## INFORMATION BULLETIN NO. 21

**TO: OWNERS AND OPERATORS OF FLETCHER MODEL DDO AND DDJ ROOF DRILLS**

**SUBJECT: FRONT END LIFT ARRANGEMENT ON MODELS DDO AND DDJ**

WELD AREAS FOR RETAINER

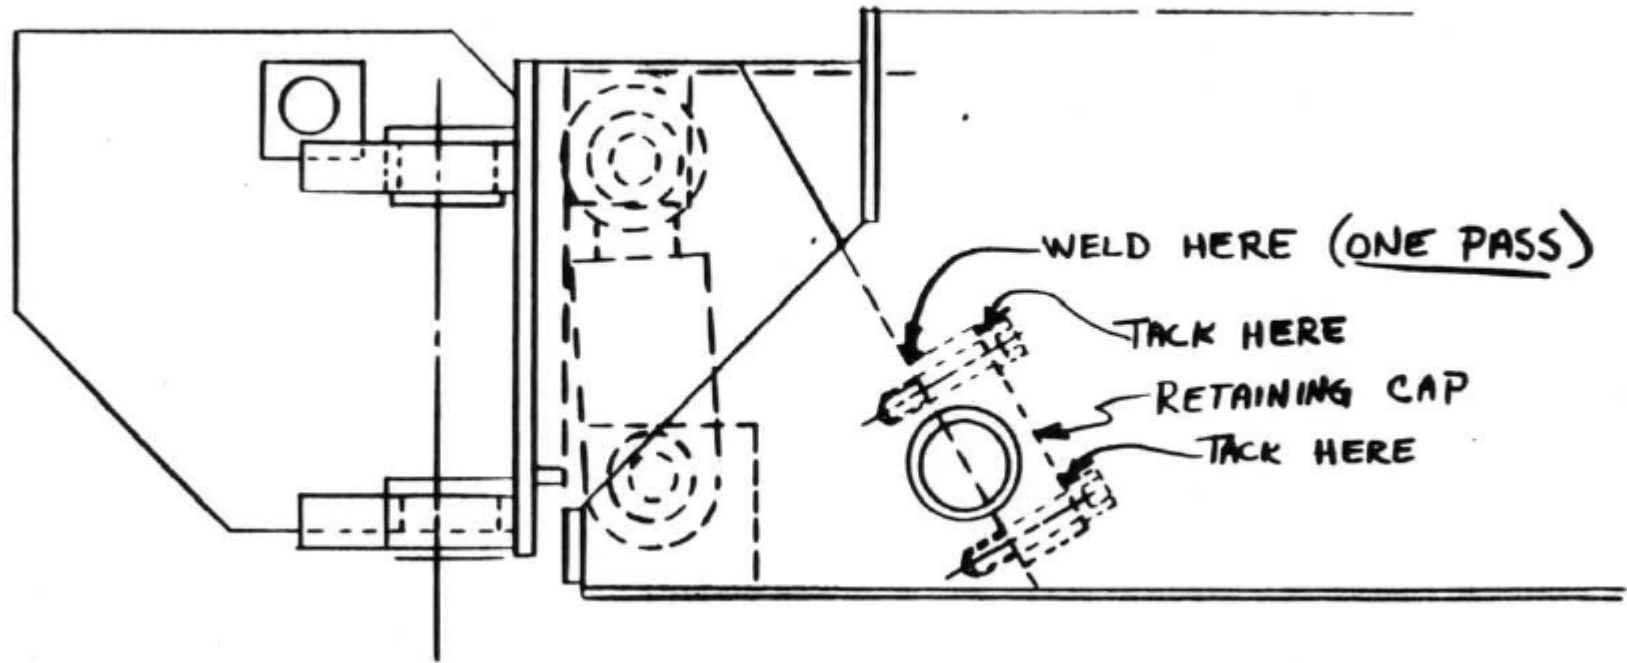
The allen head screws in the retaining cap for the bronze bushing begin to back out after continued use of the front end lift system.

To prevent this occurrence, tack weld the allen head screws along with welding the retaining cap to the pivot plate.
